13-010226-CLN-01

**TO: DISTRIBUTION**  
**FROM: C NEUMEYER**  
**SUBJECT: MINUTES OF MEETING ON OH HIPOT LEVEL**

Decide on the upcoming OH hipot test voltage:  
Should it be reduced from 13kV to a lower value (e.g. 9kV)?

Fig. 2-10 Flatwise Tensile Test Results of Turn-To-Turn Insulation

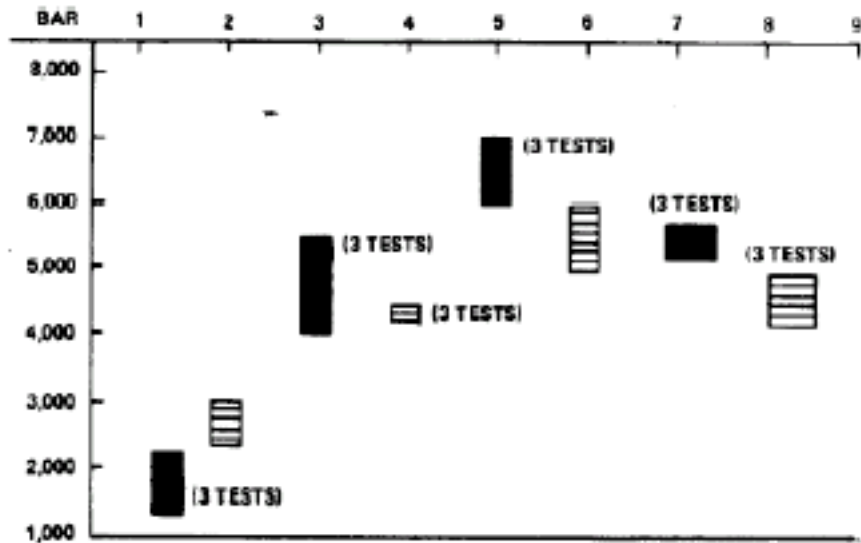
As we discussed, the 30 C adiabatic temp. rise should result in a max. dT of .7 x this, or 21 C, which is the dT Art and HM used in their calculations. The figure above is from the TFTR RDAC and shows the flatwise tensile strength in several glass/epoxies. I would expect the DOW DER-332 to be very similar (if not weaker) than the CTD-112 used in NSTX. This data is,

fortunately, also based on the use of DZ-80 primer as in NSTX.. (The top axis shows the bar numbers; 5&6 are for the DER-332). This shows the flatwise tensile strength to be in the range of 4.5-7 ksi. HM's analysis (13-001208-HMF-01) indicates a maximum tensile stress of 1.9 ksi. and a maximum combined shear of 2.07 ksi. If we assume that the tensile load reduces the shear allowable by (tensile stress x 0.3) or 570 psi, the allowable would be 2.9-.57, or 2.33 ksi. Based on this, I conclude it is safe to proceed with the 30 C adiabatic temp. rise. As we are getting close to the shear allowable, I recommend that be considered the limit.
